Rundschreiben: Gruppe: Getriebe: No. 2 Seite 2/2 - 19.06.1942

Betr.: Getriebe BMW R75

Probleme mit der Druckfeder des Rastenhalters des Anwerfers

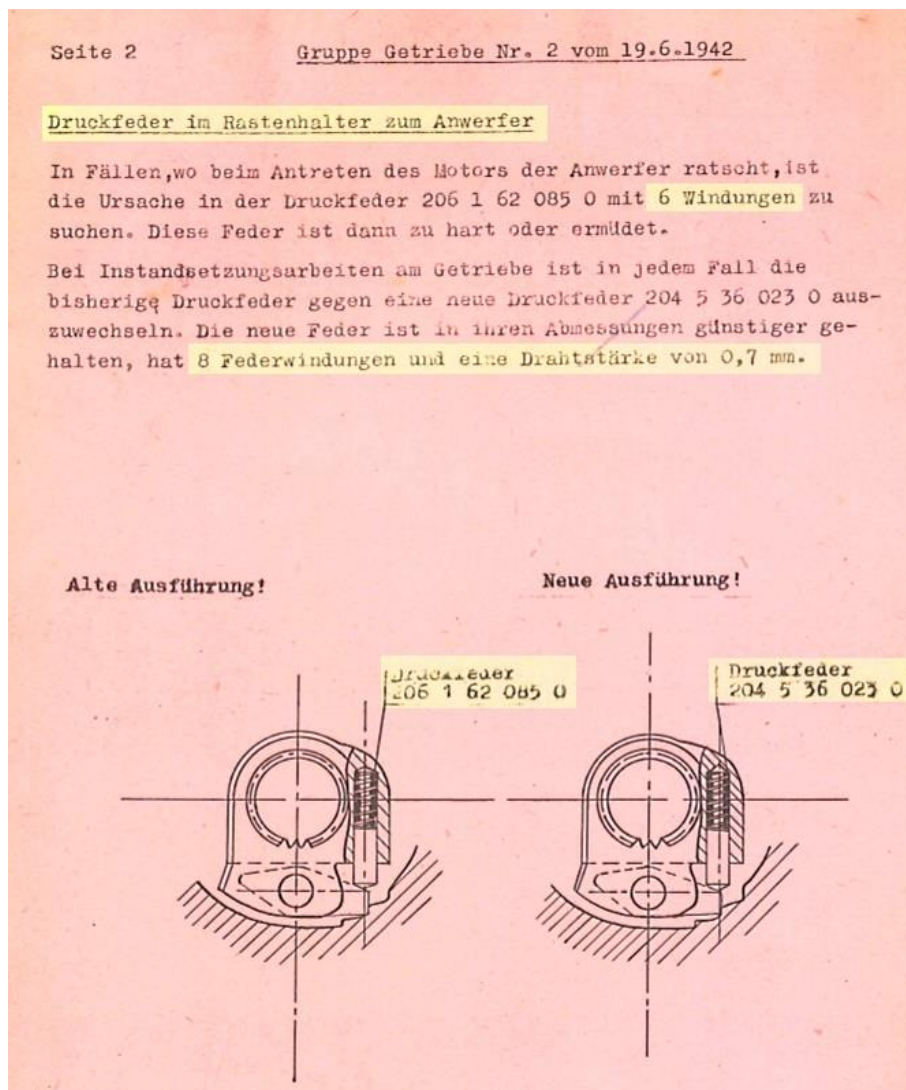
In den Fällen, wo die Raste des Rastenhalters nicht in den Eingriff des Zahnrades eingreift, ist die Ursache die Druckfeder.

Dass die Feder einfach zu unelastisch ist, wird hier mit der Behauptung kaschiert, „Die Feder ist dann zu hart oder ermüdet.“ Ja, was nun zu hart oder zu weich? Unpassend wäre der richtige Ausdruck. Aber damals wie heute sind Hersteller bei Fehlern ihrerseits recht kreativ beim Verschleiern.

Es wurde hier eine Feder verbaut, die bereits im Ersatzteilprogramm vorhanden war. Die Ersatzteilnummer beginnt mit 206. Ebenfalls die zum Ersatz vorgegebene Feder ist bereits im Programm erhalten und beginnt mit 204.
